24 August 2016

**PROJECT: RESOURCECO WETHERILL PARK DEVELOPMENT 35 – 37 FRANK STREET, WETHERILL PARK  
NSW  
RE: MINOR AMENDMENTS TO STATE SIGNIFICANT DEVELOPMENT APPLICATION SSD 15\_7256**

**Re: Resource Co Resource Recovery Facility,  
35-37 Frank Street, Wetherill Park - Landscape Statement**

1:100 @ A1

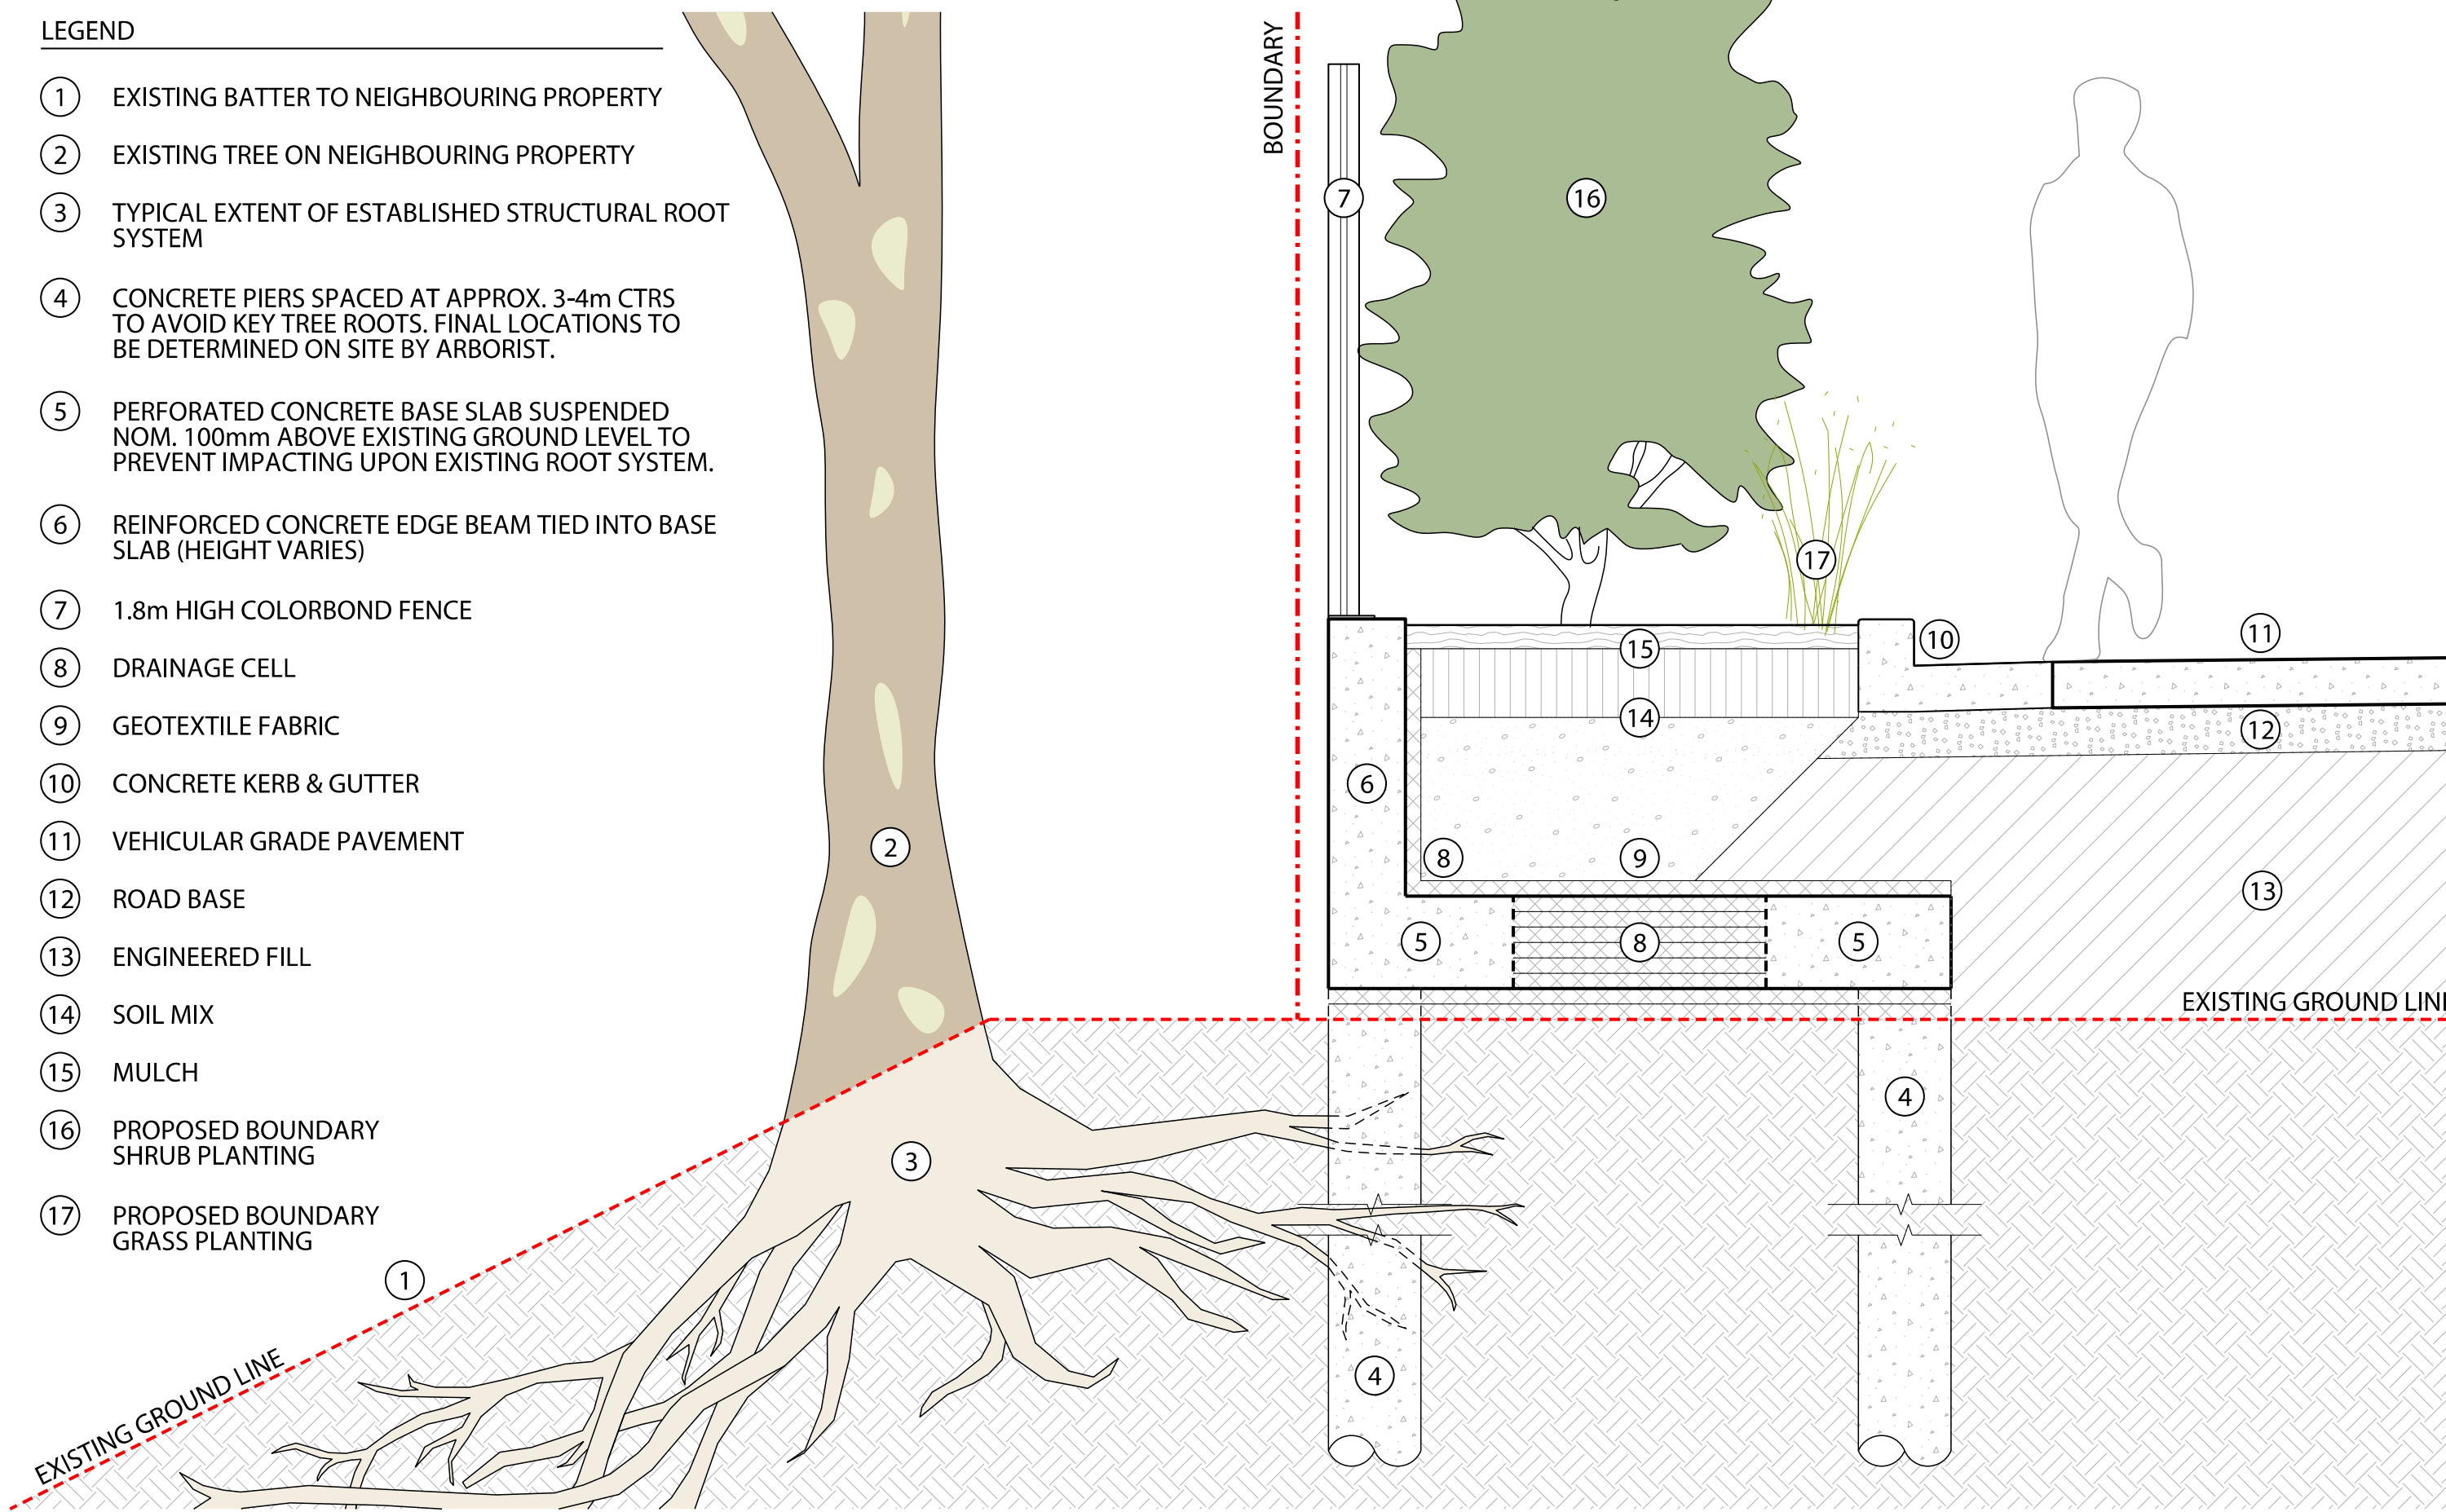
As a result of the revised site levels, the retaining wall to the Northern boundary has been reduced from 5.2m high to 3.25m high. The retaining wall to the Western boundary has been reduced in height and length (terminating near the weighbridge). There is a stronger street address (i.e. better visual connection / less segregation) with Frank Street as the reduced site levels have negated the need for retaining walls along the Southern boundary and allowed for a slight increase in garden bed area.

Along the Western boundary a variable height retaining wall is still required to accommodate a variable level shift of the neighbouring industrial estate. This retaining wall system has been designed to minimise impact on the root zone of the existing neighbouring trees, in accordance with arborist recommendations. A 1.8m high fence will be installed along the retaining wall and return along the northern boundary. The western boundary will also be planted with screening shrubs and grasses to improve visual amenity.

2 Wall Type B to Northern Boundary Detail Section

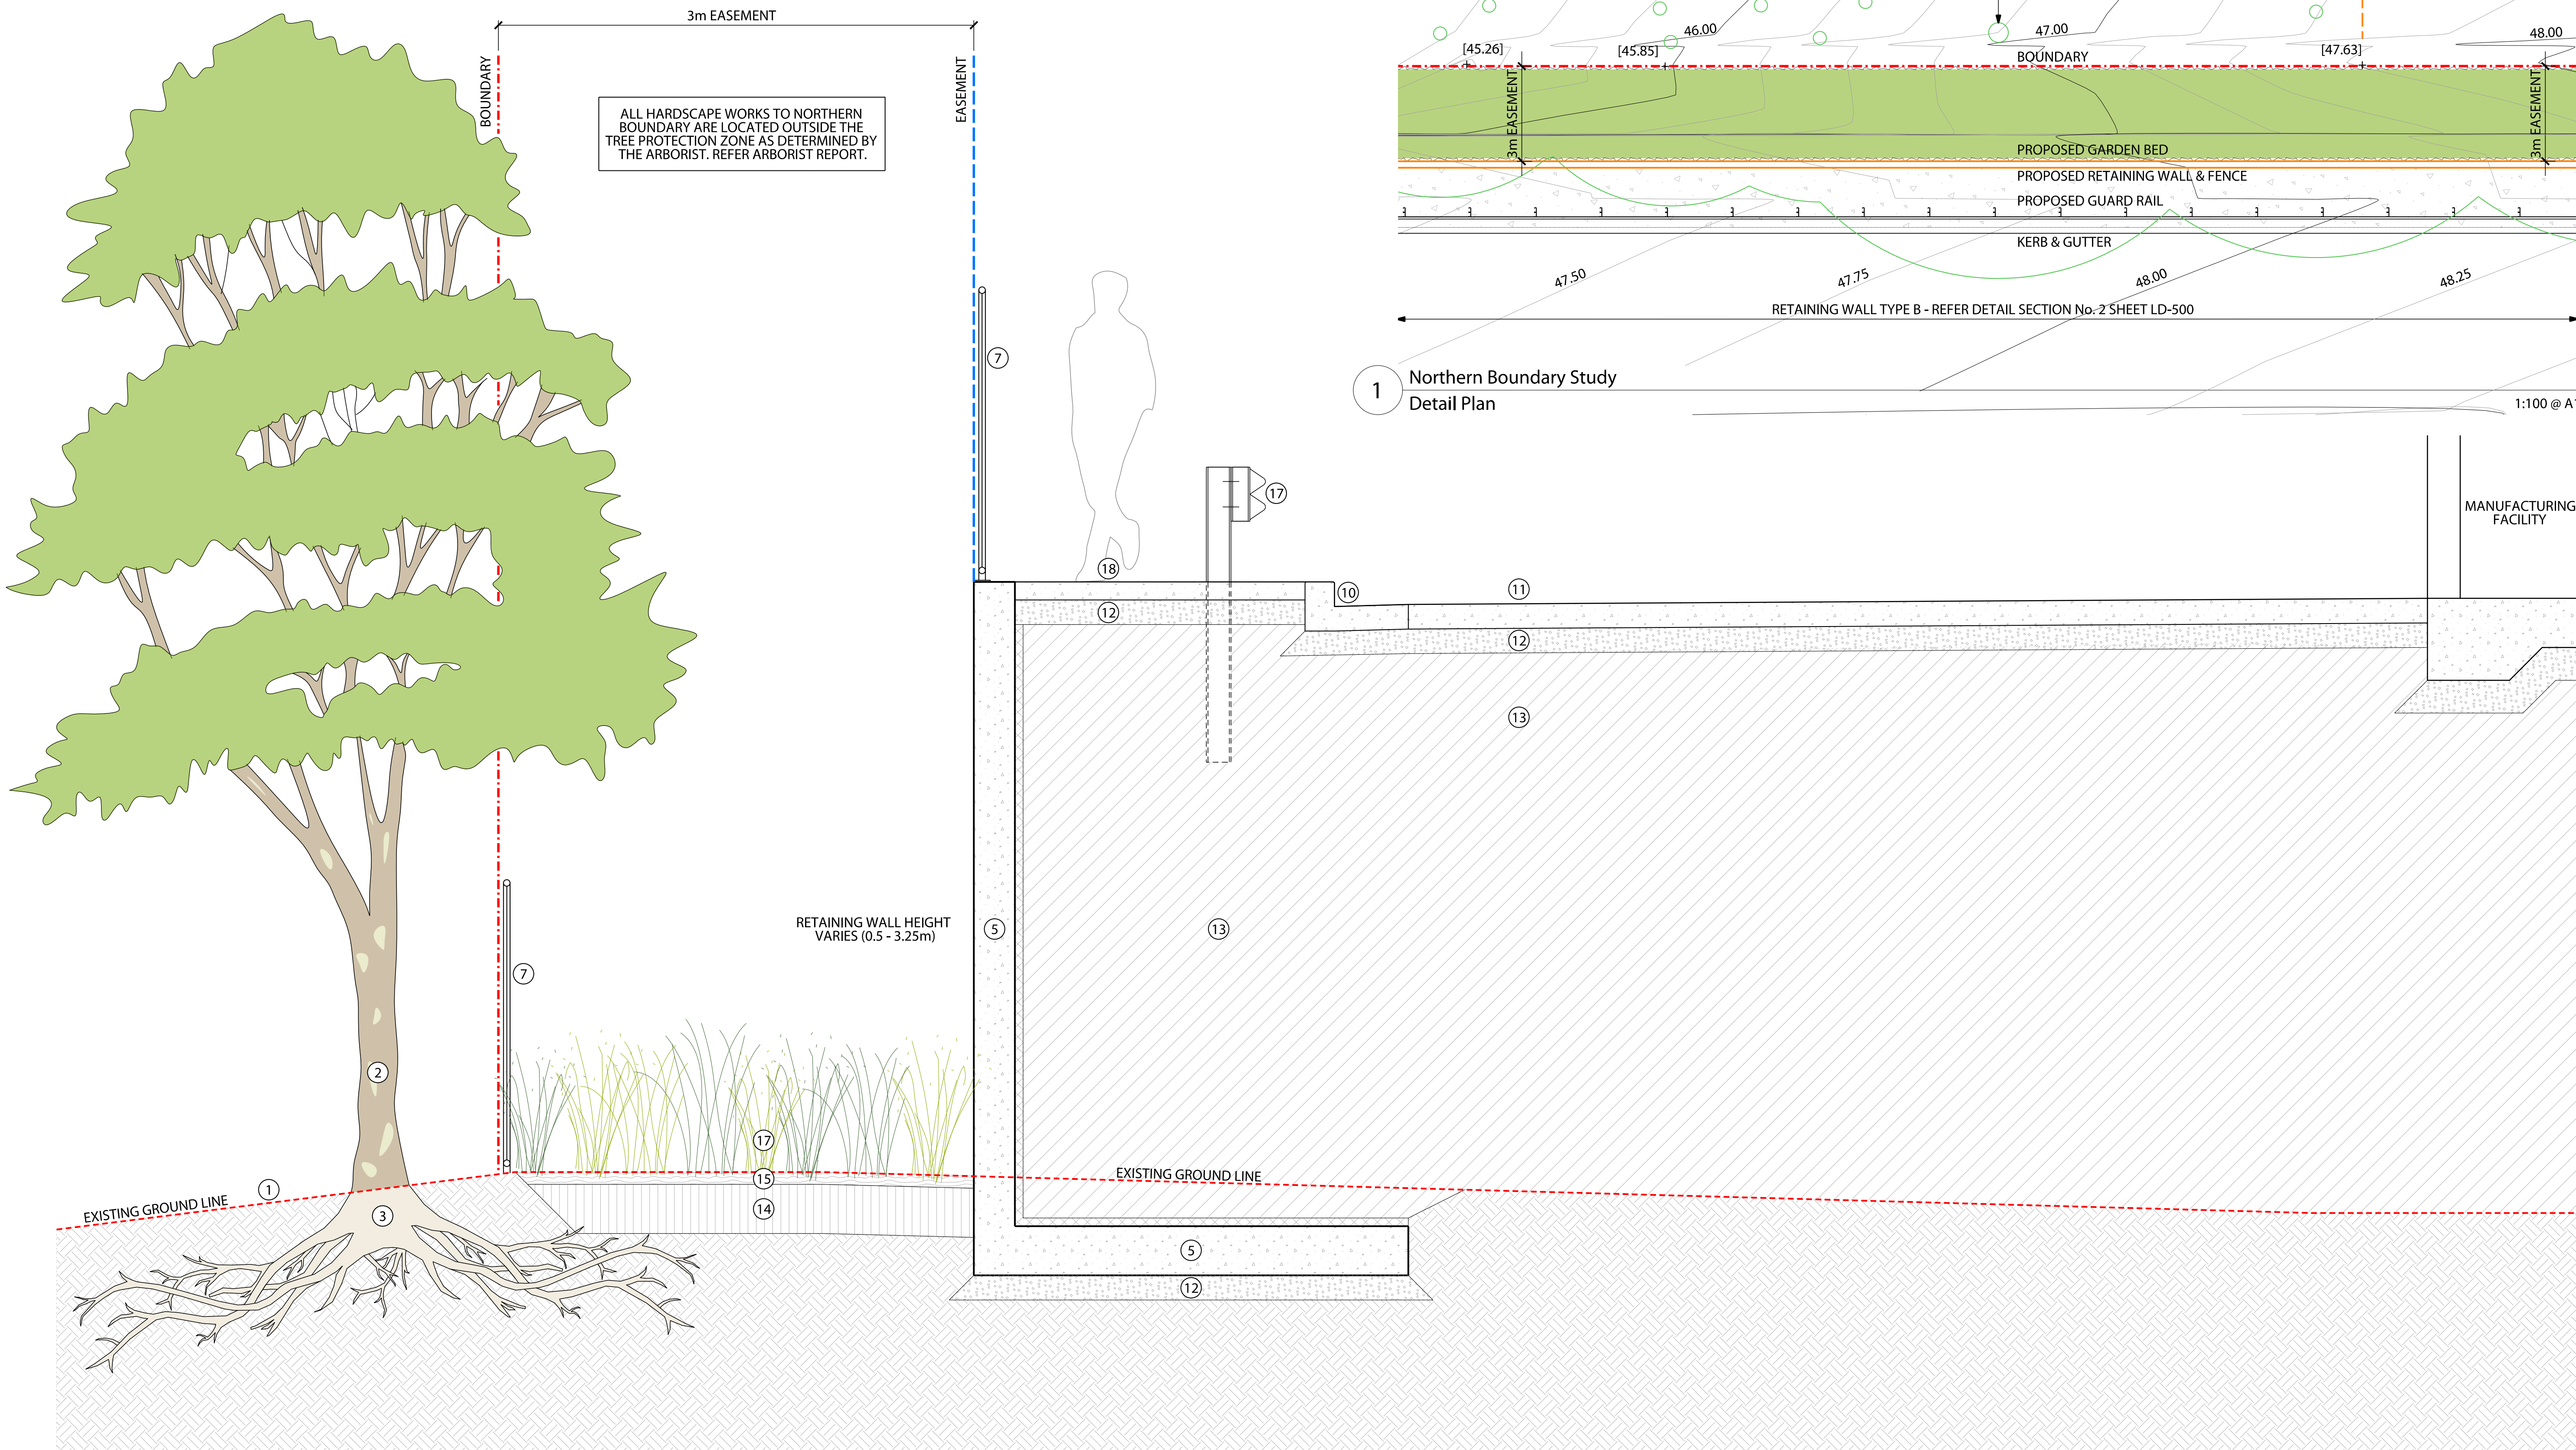
A retaining wall is proposed along the Northern boundary, and 3m clear of the Northern boundary easement, to accommodate a variable level shift with the neighbouring industrial development. This wall will include a vehicle safety barrier, concrete footpath and 1.8m high fence.
